DESIGN <i>CP</i>	DRAWN BY <i>JP</i>	DART AEROSPACE LTD HAWKESBURY, ONTARIO, CANADA	
CHECKED <i>TH</i>	APPROVED <i>AS</i>	DRAWING NO. DSI 9246	REV. A SHEET 1 OF 1
DATE 03.02.06		TITLE QUICK RELEASE KIT	SCALE NTS
A	03.02.06	NEW ISSUE

## DART SERVICE INSTRUCTION

TO AMEND INSTALLATION DRAWING D206-540 REV. H

REF. CANADIAN STC: SH94-5

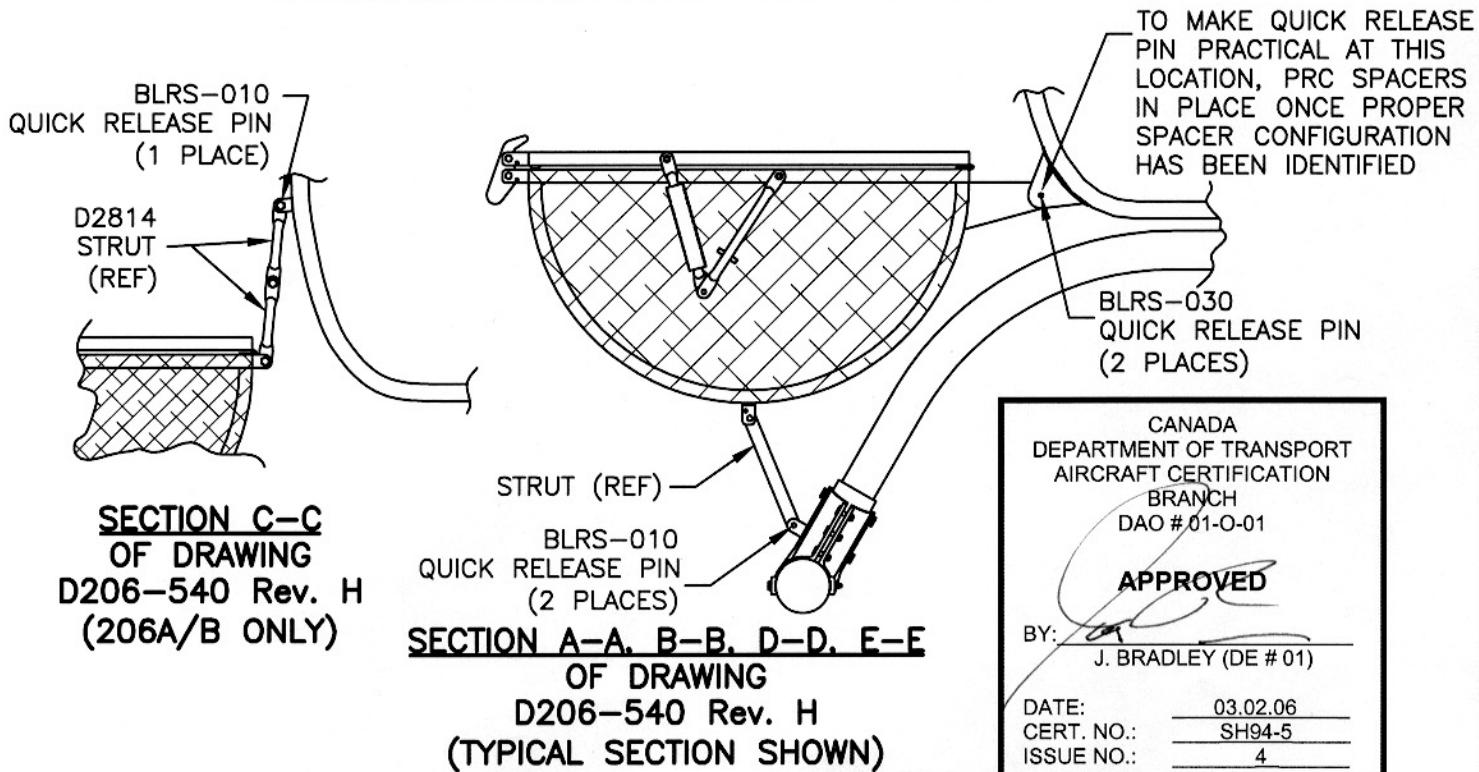
**PURPOSE: TO ALLOW SUBSTITUTION OF THE BASKET ATTACHMENT BOLTS WITH QUICK RELEASE PINS**

THE AN4-12, AN4-12A, & AN4-21A BOLTS MAY BE REPLACED WITH STAINLESS STEEL POSITIVE LOCKING QUICK RELEASE PINS WITH A MINIMUM DOUBLE SHEAR STRENGTH OF 2400 LBS AND 0.25 INCH DIAMETER

BOLT	MIN GRIP	POSSIBLE QUICK RELEASE PIN REPLACEMENT
AN4-12	1.0"	AVIBANK: BLC4B10S, BLC4TA10S, BLC4R10S, BLC4LA10S MS NUMBER: MS17984C410, MS17985C410, MS17986C410, MS17987C410 REID: BLRS-010, BLBS-010
AN4-12A		
AN4-21A	1.8"	AVIBANK: BLC4B20S, BLC4TA20S, BLC4R20S, BLC4LA20S MS NUMBER: MS17984C420, MS17985C420, MS17986C420, MS17987C420 REID: BLRS-030, BLBS-030
